Modified Heart Rate Transmitter RYP 25002D, Suunto Smart Belt

Feature changes compared to t6 chest belt:

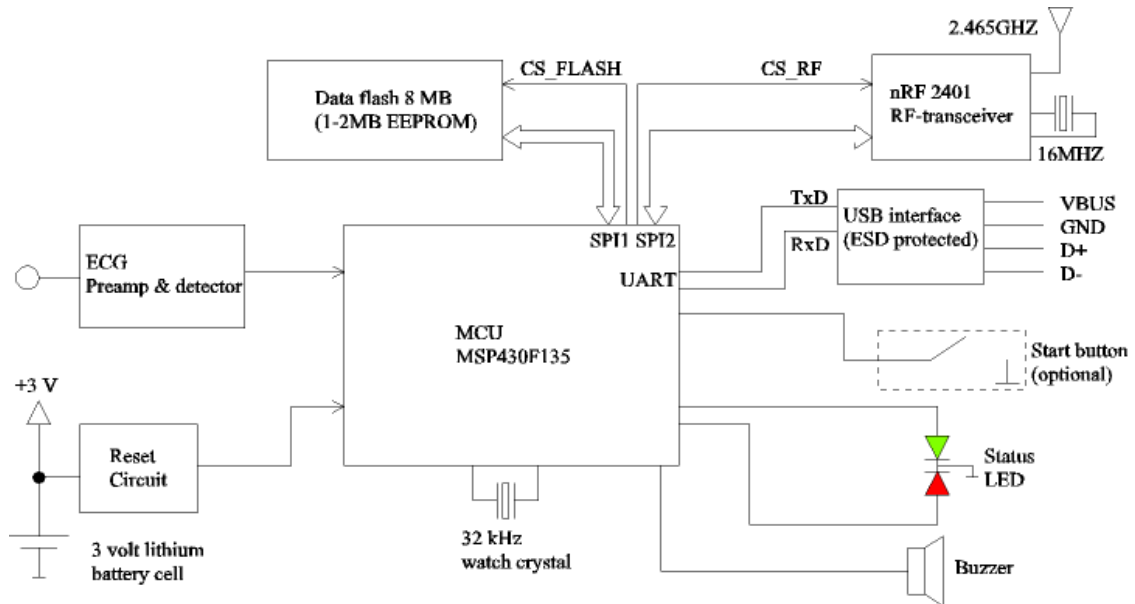
- MCU type changed from MSP430F123 to MSP430F135
- Status led, buzzer, USB interface and flash memory added
